FINAL REPORT

With comments and remarks by ex-
perts of claimants

requested by judgment of the 8th of July 2015
issued by the HAGUE DISTRICT COURT
(Chamber of Commercial Affairs)

Accident occurring in FARO Airport – Portugal
21st of December 1992

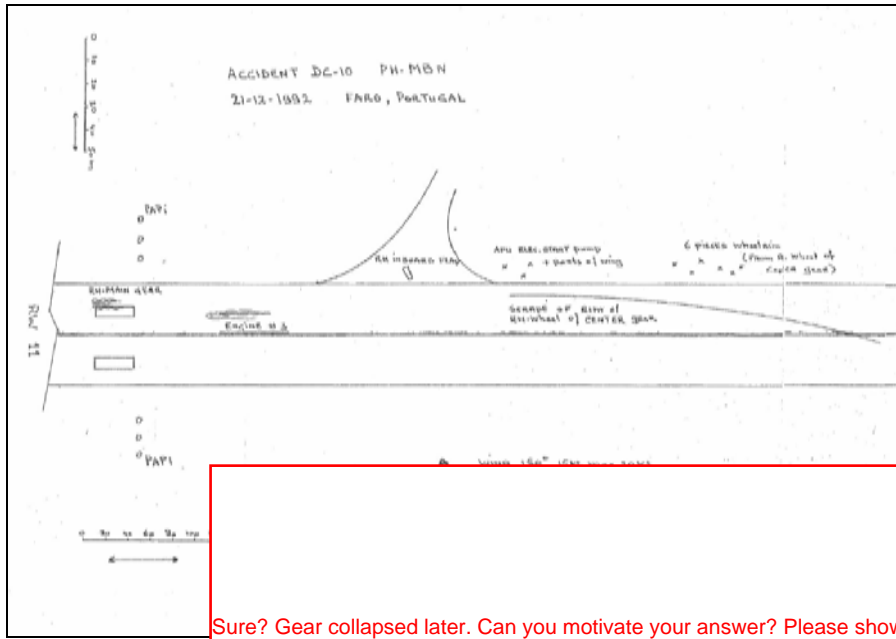
Why don't you say here that the DC-10 is not approved for landing with crab angle. AOM 3.3.5-15:Landing on a wet

Why not mention that go-around was impossible because thrust was at flight idle, and that, after touchdown, the sp

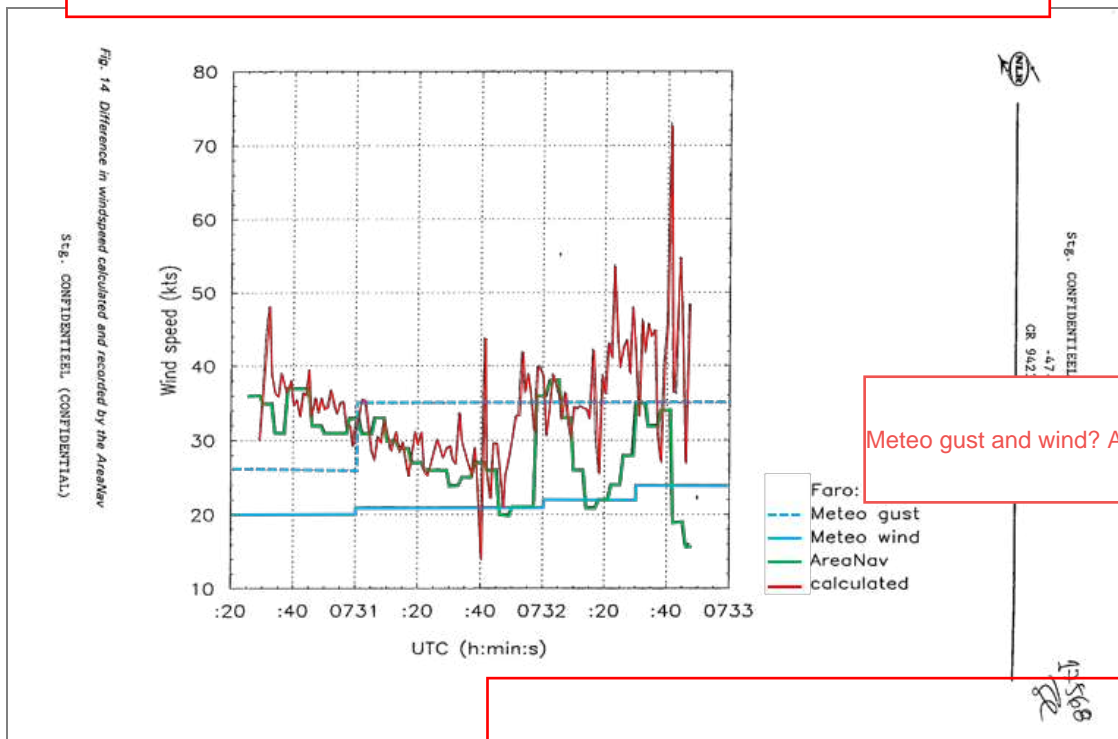
Do you agree with downbursts after reviewing DFDR data? And how did you derive these winds? How

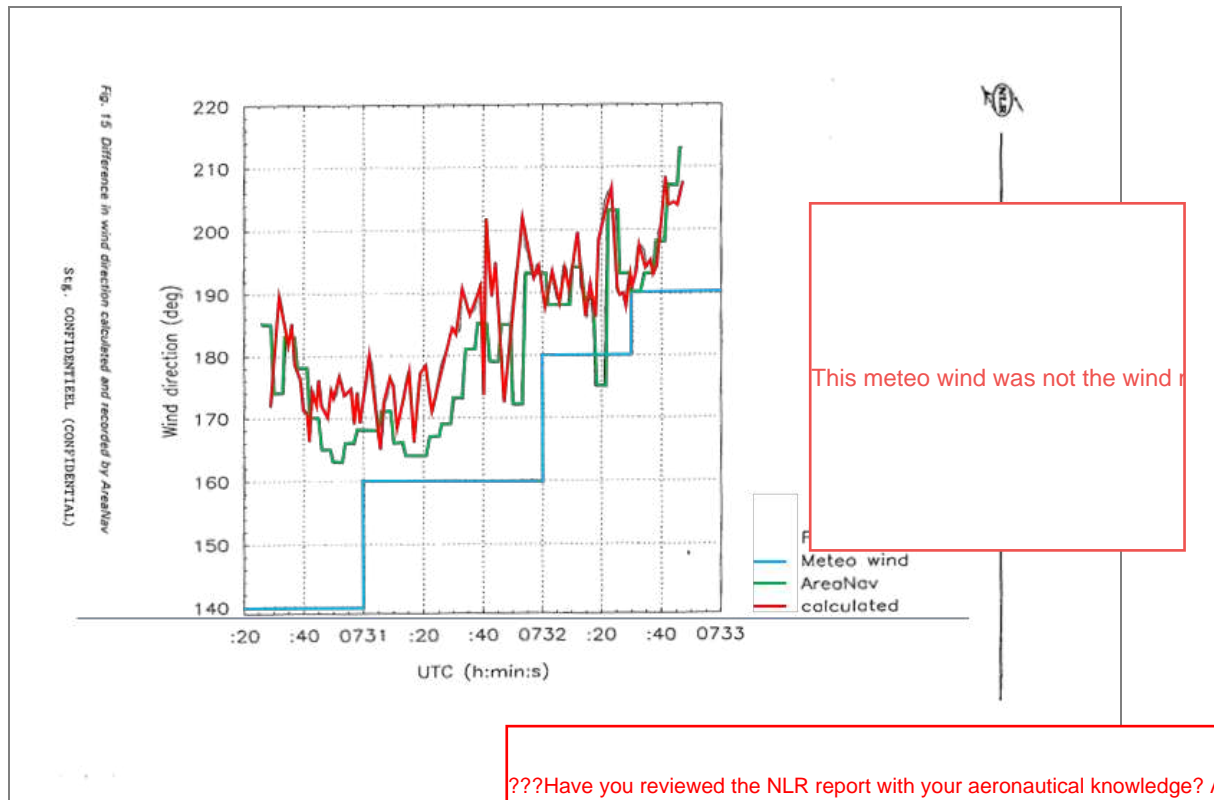
Meteo gust and wind? At the airport, c

Where is the AeraNav data from? And what does calculated mean? Ho

Fig. 4 Groundspeed and True Airspeed time history

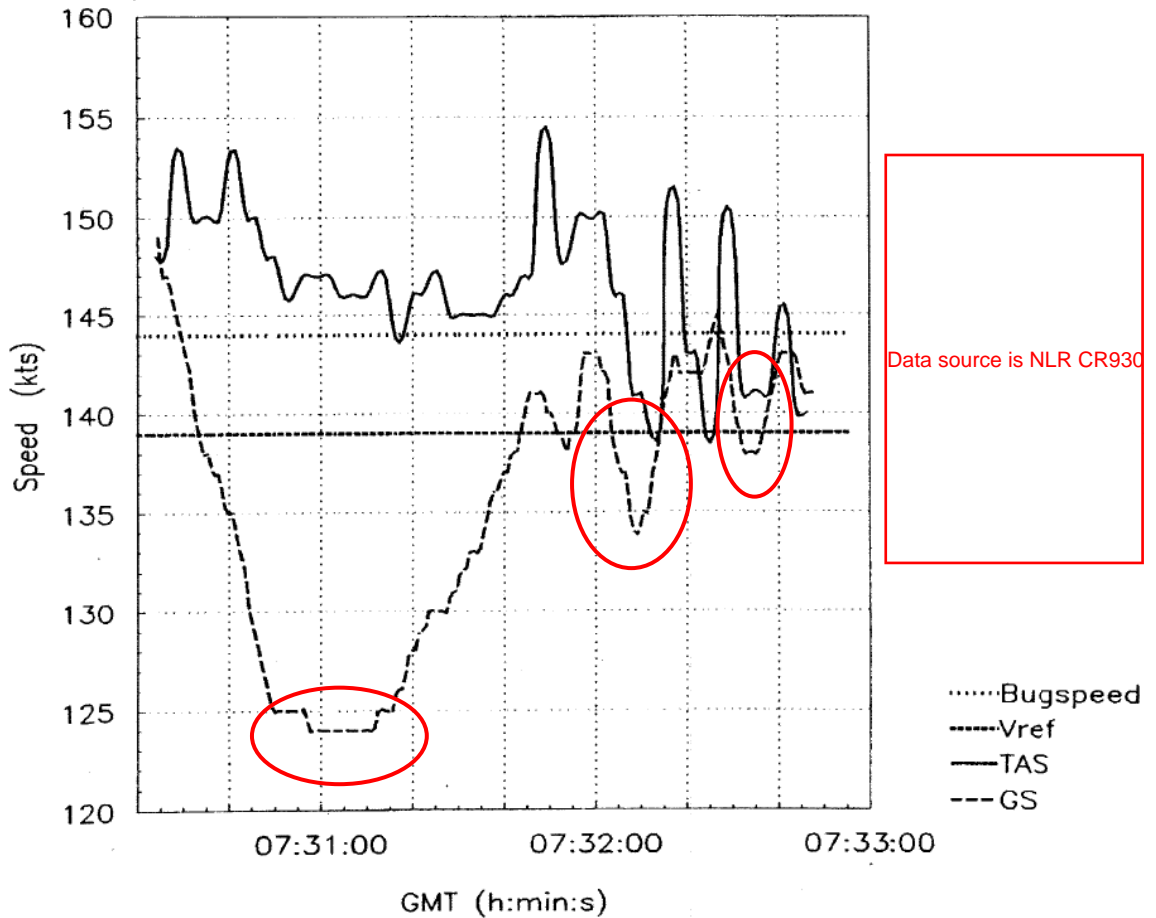
Have you conducted a heading

Experts copied NLR text, and obviously did not analyze or verify the data themselves

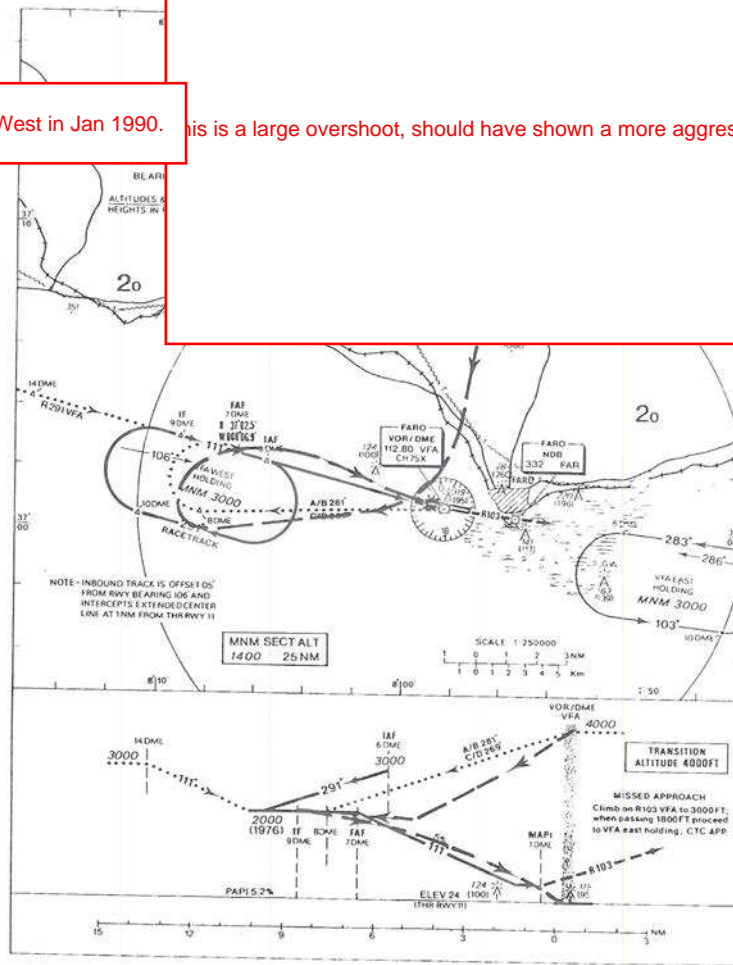
In this configuration, the bank angle is set at 25°, matching with the value used to define this turn. ?? DFDR data shows max 17° during this turn.

No, not 'obviously'; only if pilot is too

Where is your analysis? Did you write it down?

Figure 4: Lateral Flight Profile based on radar data (final segment, zoomed in Google Earth projection) (Cyan: Corrected radar track; Green: Shifted corrected radar track)

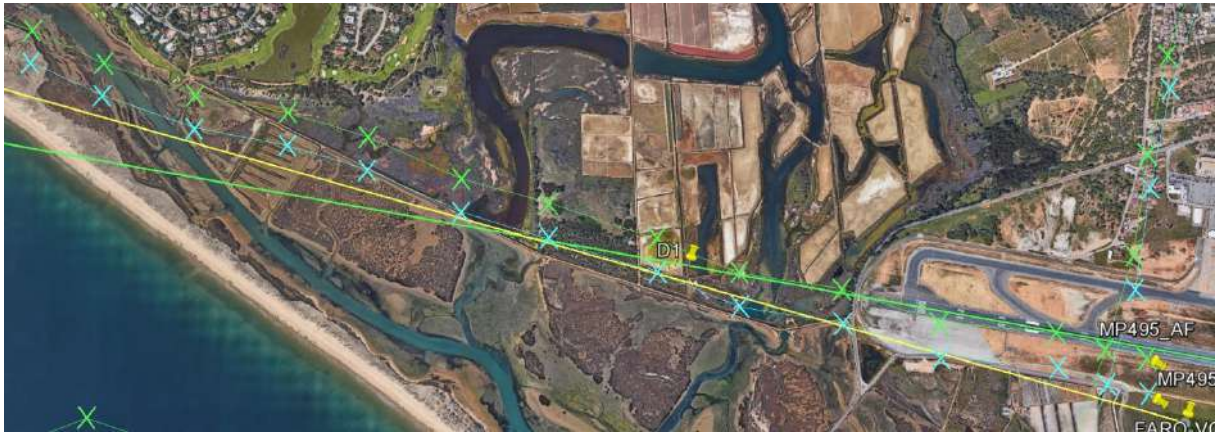
What was the radar horizon? Are the data from below 500 f

Is this allowed in an objective analysis

Figure 8: Vertical Flight Profile based on radar data

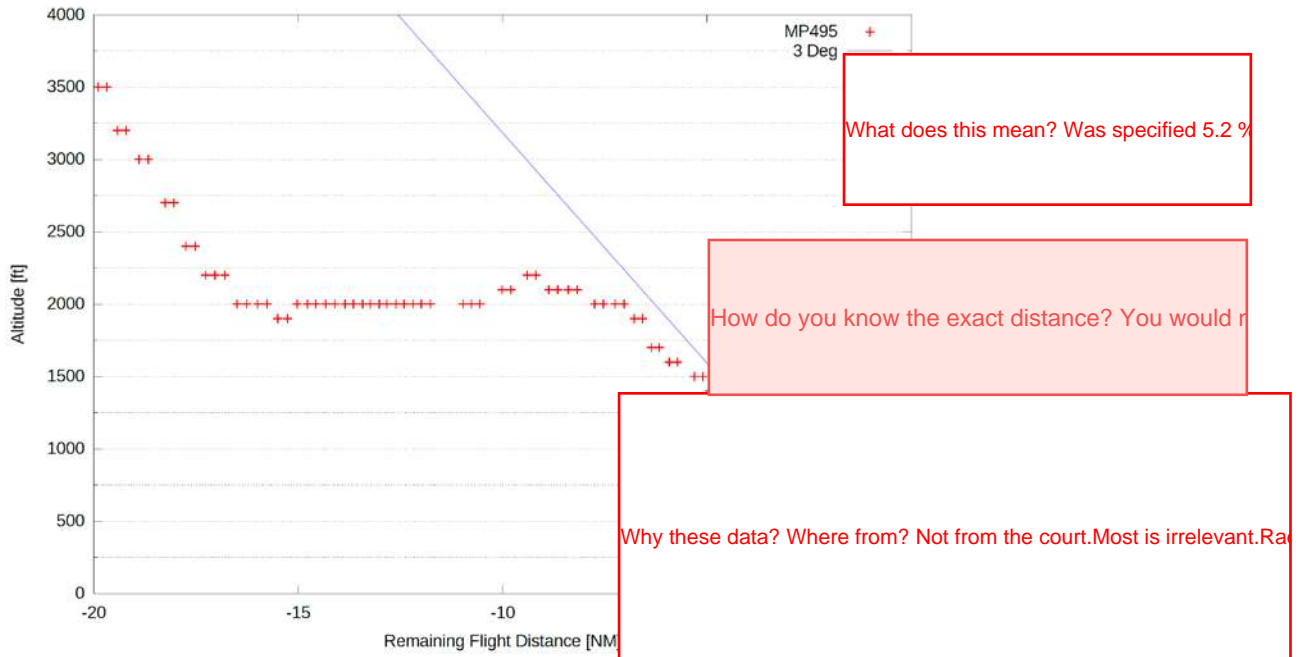
Then why and how did the airpl

Fig. 16 Lateral flight path - small scale

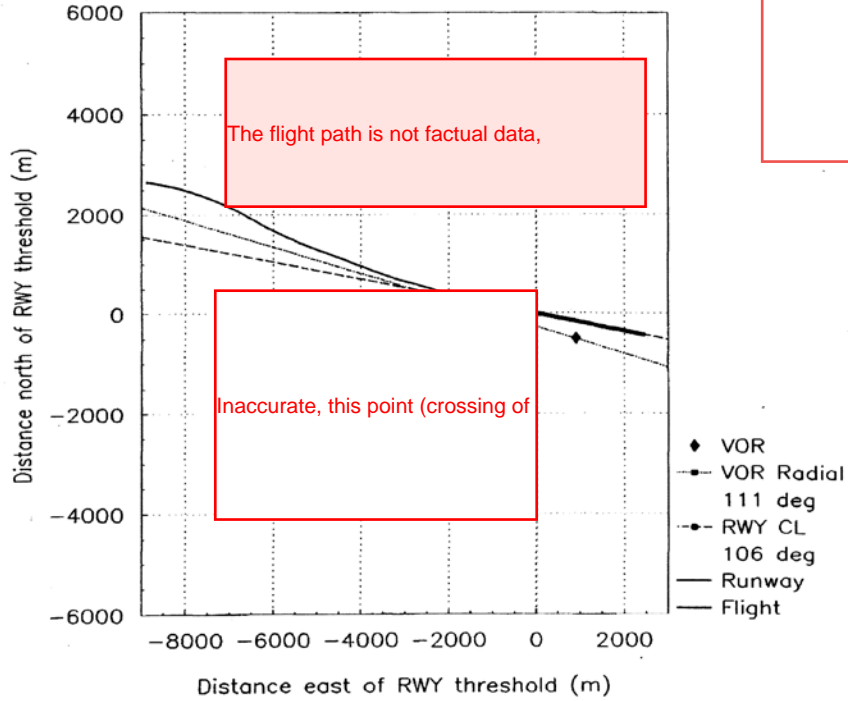
Note: This chart of the final NLR report CR93080C has been used following the team correct indications in the Interim Report V17. ??

What is your motivation to write

This figure is out of an NLR re

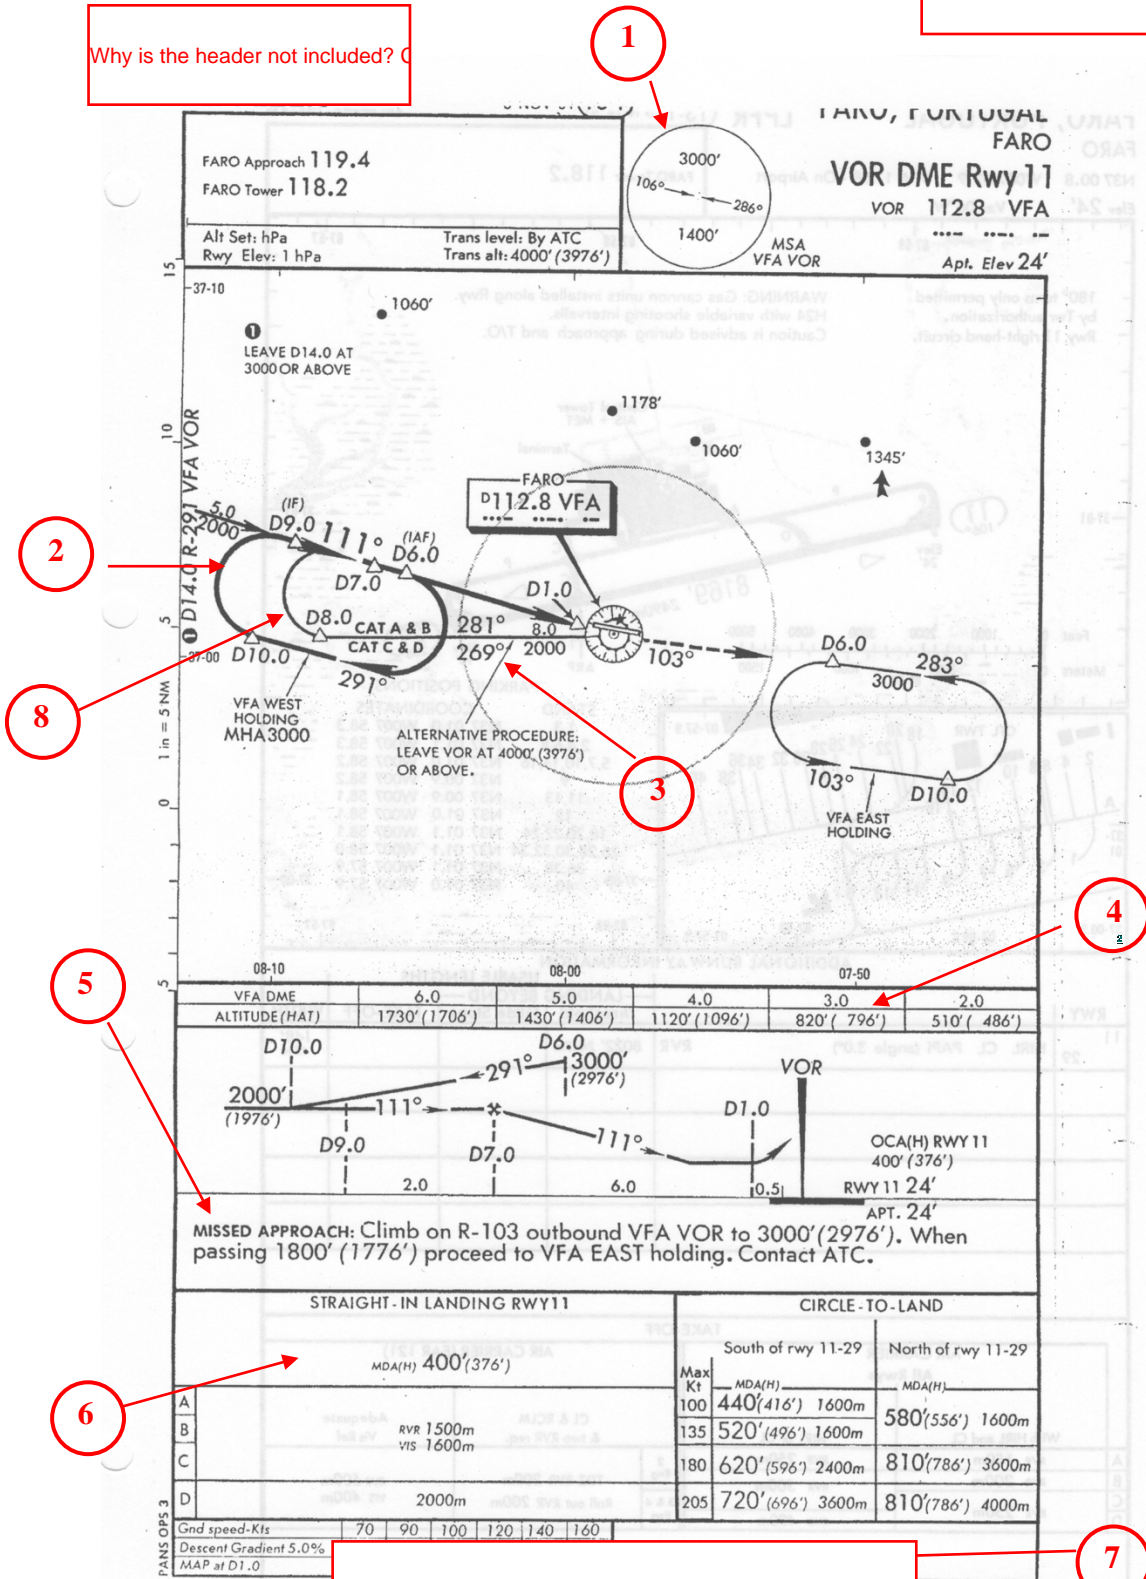
The origin of the flight path data is not made clear. Ex

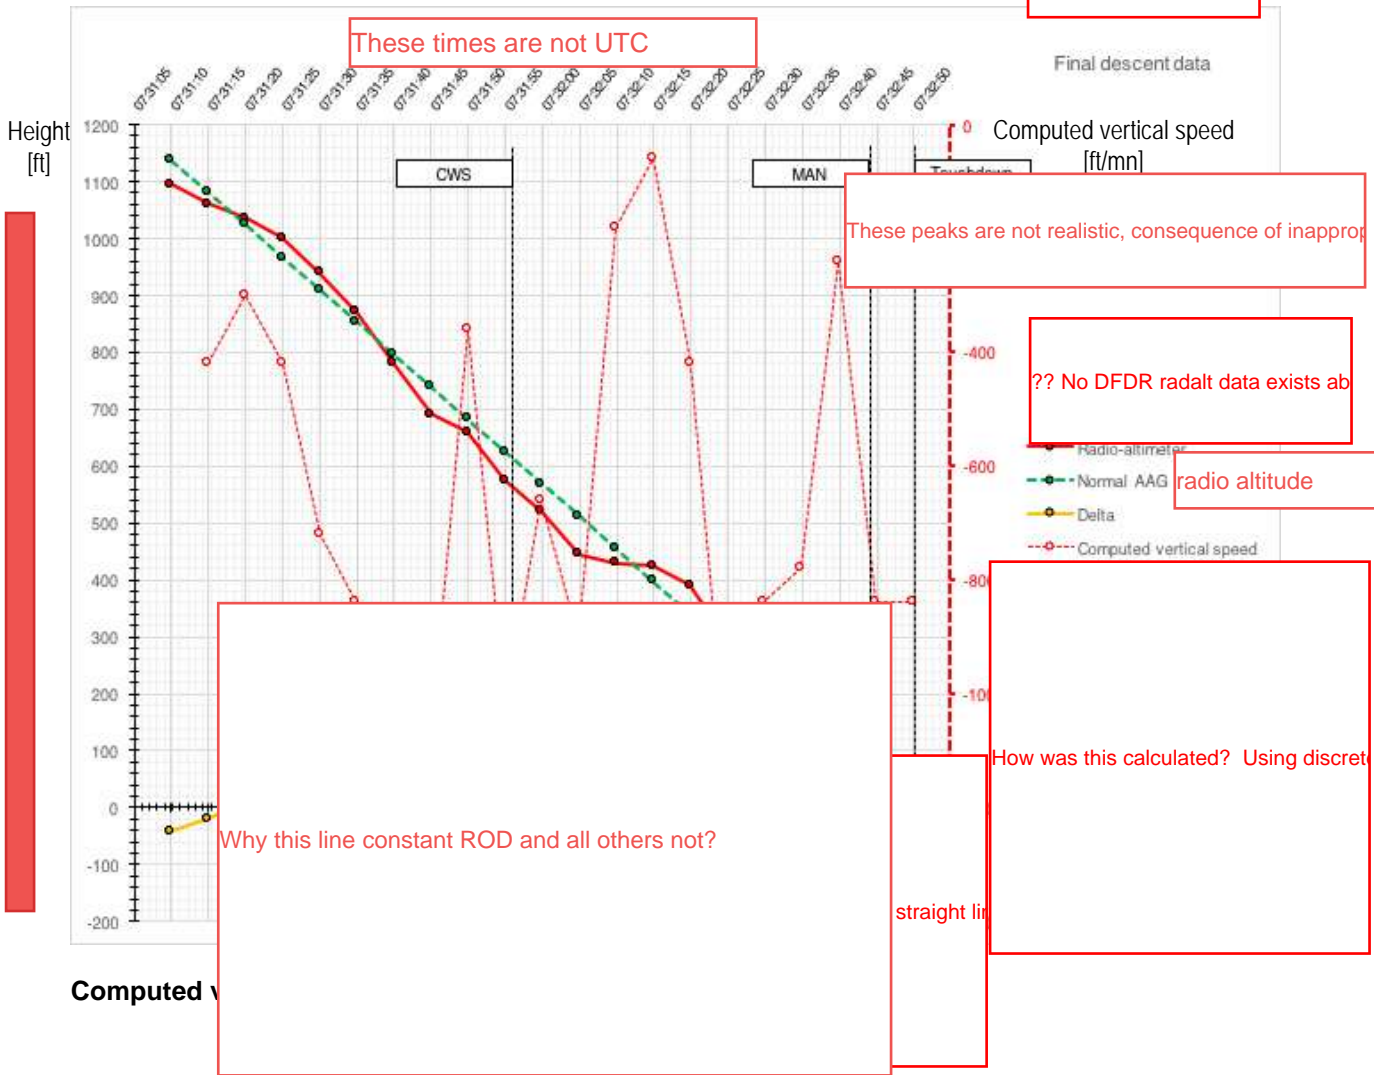
Portuguese AIP? Do you have that? Wa

This was not a very good analysis. No reference to DFDR and AIDS data with pilot inputs.

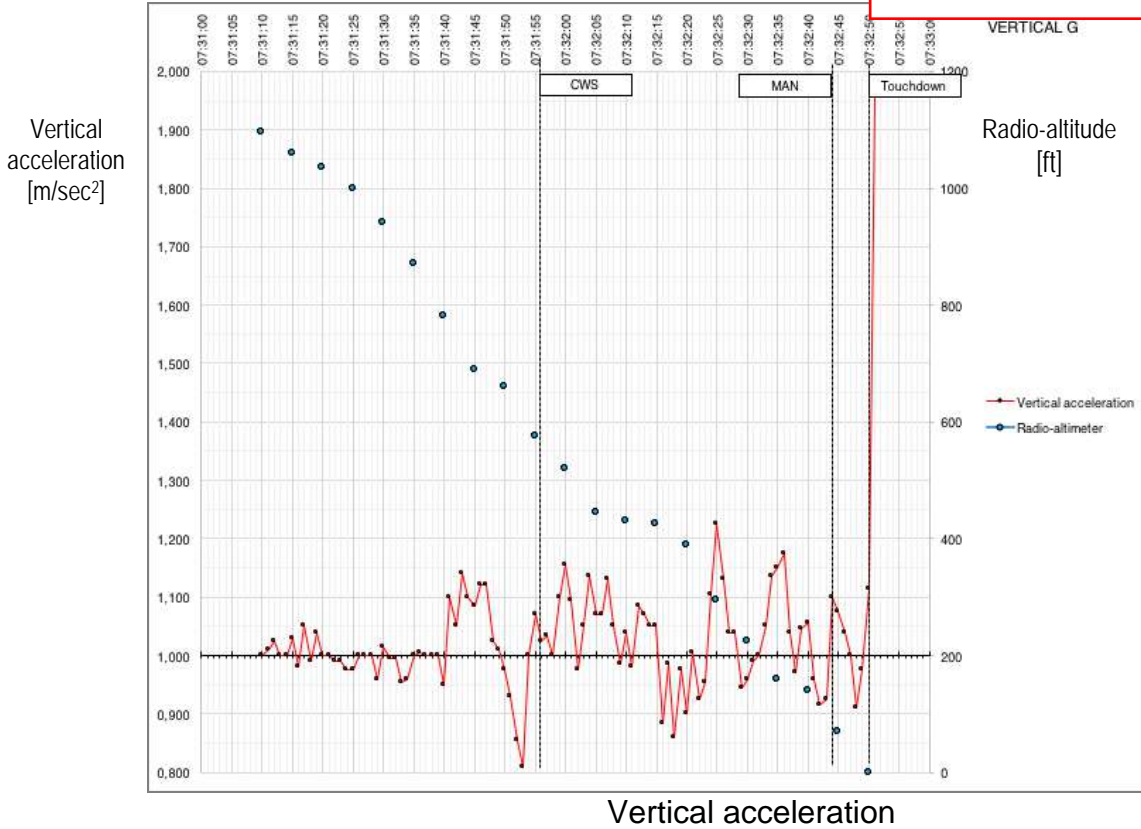
?? What's wrong?

14 seconds!

more comments to be made
